REPORT TO COUNCIL

Application: DP16-0091 / DVP16-0092 & DP14-0197-01 / DVP16-0217 **Owner:** Al Stober Construction Ltd.

Address: 1545 Bedford Ave & 1525 Dickson Ave **Applicant:** Meiklejohn Architects Inc.

Subject: Development Permit and Development Variance Permit Application

Figure 3: Phase 1 Original Plan
Original Landscape Parkade Roof Plan
Original Landscaping that will be eliminated
Original Property Line

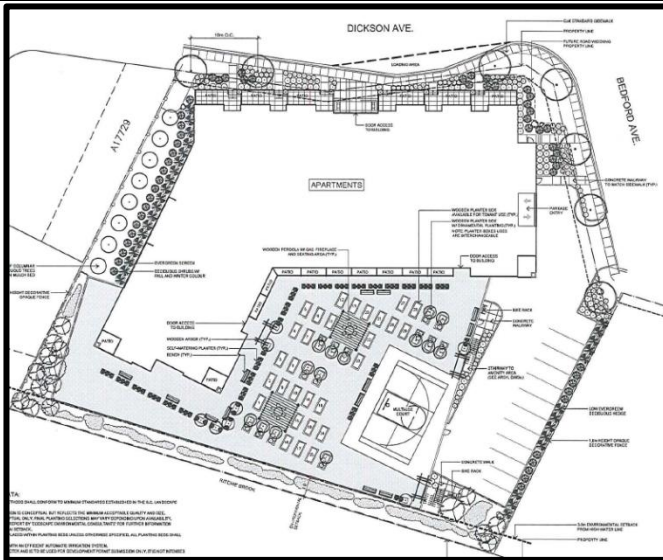
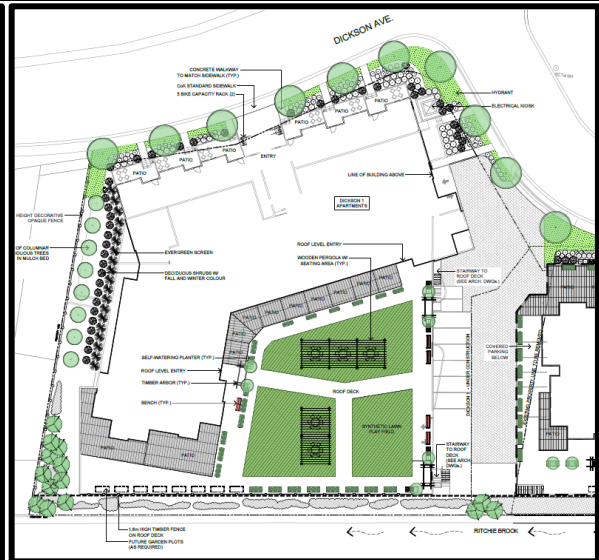
This development proposal involves amending the developer's previously approved Phase 1 plans (located at 1525 Dickson Ave) which is currently under construction. The amendments include moving the shared property line in order to create a single access parking lot to both buildings from Bedford Ave. The parkades from both projects will be accessed through this shared parking lot. This change has precipitated variances related to parking setback and landscape buffer reductions. The applicant has downgraded the landscape island areas within the surface parking area (see applicant's landscape rationale letter for more details). However, the diagram below illustrates the changes to the phase 1 area.

Figure 4: Phase 1 & 2 Amended Plan
New Landscape Parkade Roof Plan
New Property Line
Original Property Line

Drawing Title:
SITE PLAN

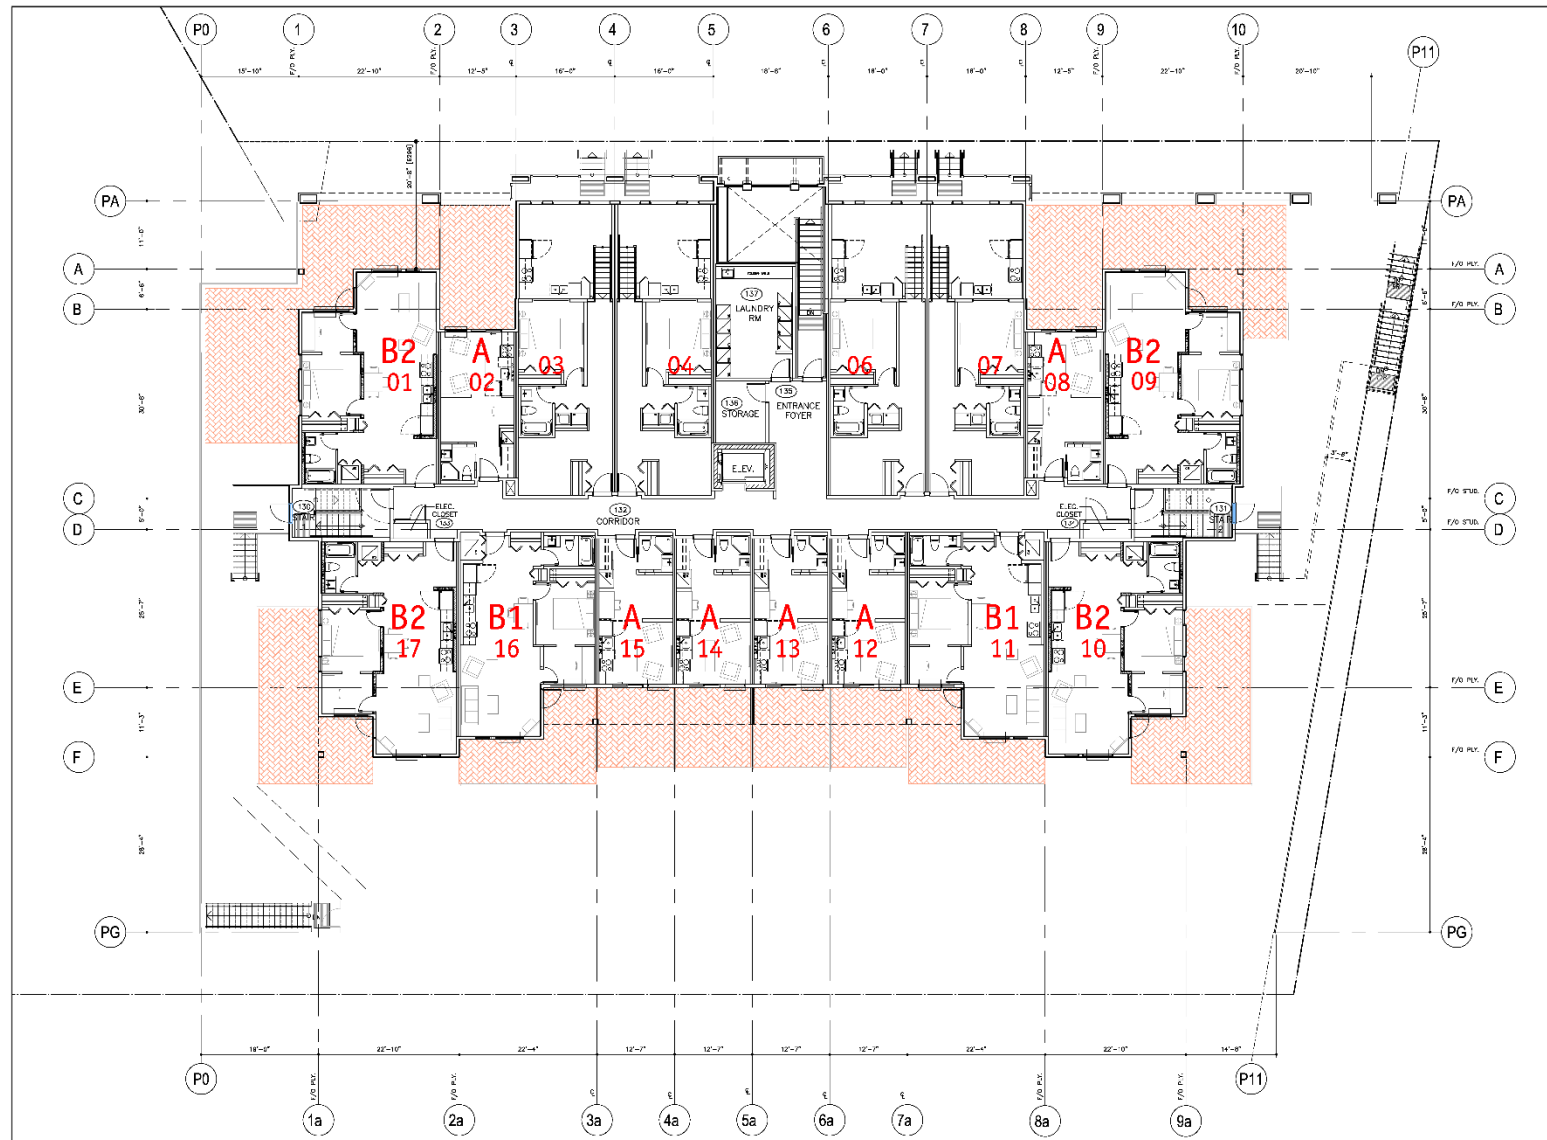
- 1.Delete garbage/recycling room and share with Dickson 1 across the driveway. Add 2 parking stalls.
- 2.Add bike racks on the wall next to parking stalls.
- 3.Reduce electrical rm size & add bike rm at front of building.
- 4.Reduce mechanical room & add compact car stalls.
- 5.Previous parking count : 74 stalls
Present parking count : 79 stalls
